Subject: Re: ISC sled height HAM3 (W/L)

Can you check my number on the height of the ISC sled for both WHAM3 and LAHM3. I believe the height is 4.104" from the ISI table to the center of the optic as per the e-assembly? The e-assembly I uses is LIGO-D1000339:<<https://dcc.ligo.org/cgi-bin/private/DocDB/ShowDocument?docid=9329>> ISC HAM3 Assembly.

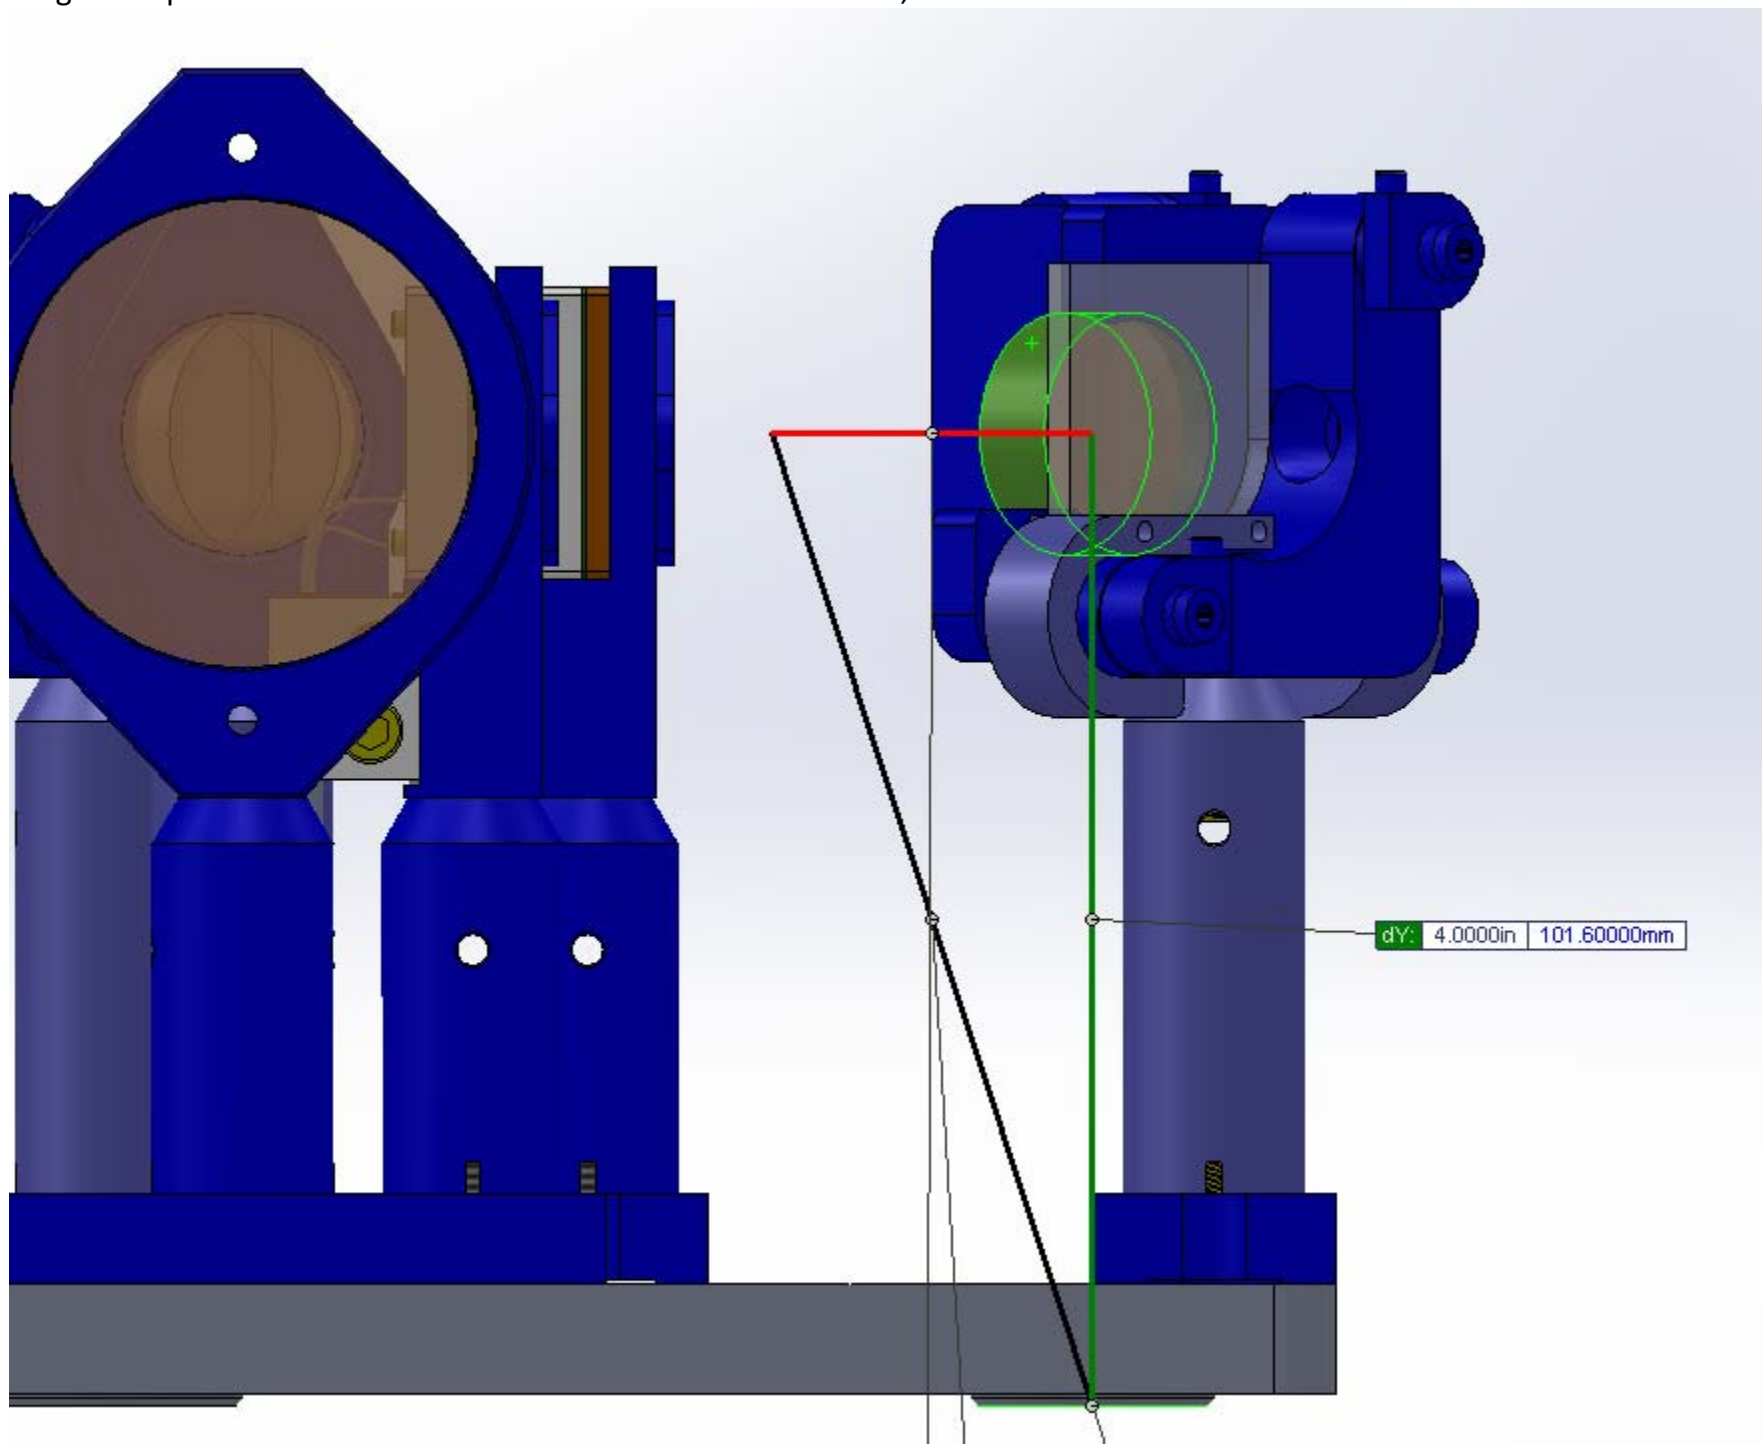
First of all I hate eDrawings... measuring is not the same in eDrawings as it is in SW. But it appears as if the Mount Post for the 1" optics in the the eDrawings is longer than the actual SW model.

Sam could add height dimension to the pdf at this link?

Height of optic centers should be 4.0" from the feet of the sled, as it is in the SW model.
